UNITED STATES PATENT AND TRADEMARK OFFICE

Office Action Summary	Application No. 10/536,865	Applicant(s) SOMERVILLE, DECLAN
	Examiner RYAN J. FRANKS	Art Unit 3633

DETAILED ACTION

Fig. 8 from Bullard

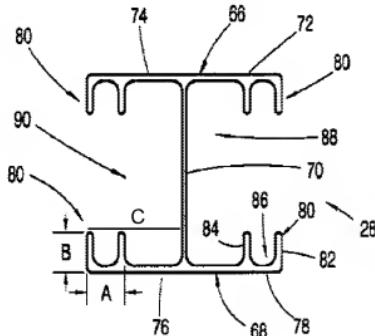
Regarding claim 1, Bullard discloses an “extrusion (column 4, line 15; Fig. 8 in general) [having] a central wall portion (70) and a surrounding perimeter portion (72/74/76/78),

whereby the central wall divides the extrusion into opposing chambers (88/90), said perimeter portion having a respective opening therein into each of said chambers (lack of material at left of 90 and at right of 88) and each chamber being able to have a perimeter portion of a further extrusion locked thereinto to form an interlocked unit."

Two extrusions are able to interlock by inserting an edge of one extrusion into chamber of another. For example, an extrusion having the same external dimensions as the internal dimension of the chamber could be inserted into the chamber.

Regarding claim 2, Bullard discloses that the perimeter has opposing pairs of sides but lacks that one pair of sides is longer than the other pair of sides. It would have been obvious to one of ordinary skill in the art at the time the invention was made to change the shape of the extrusion, for example, by making the right and left sides of Fig. 8 longer than the top and bottom sides of Fig. 8 thus having the longer sides contain the

openings to the chambers 90 and 88, since a change of shape has been held to be within the skills to one of ordinary skill in the art as a matter of obvious design choice. (See MPEP 2144.05).

Regarding claim 3, Bullard discloses that "the central wall divides the extrusion into two chambers of equal dimension." At Fig. 8, central wall 70 forms chambers 88 and 90 which are seen to be of equal size.

Regarding claim 4, Bullard discloses that "the closed side wall has external dimension that corresponds to the length of the central wall". The shorter sides as indicated with claim 2 at 66 and 68 are seen to be the same size as central wall 70 in Fig. 8.
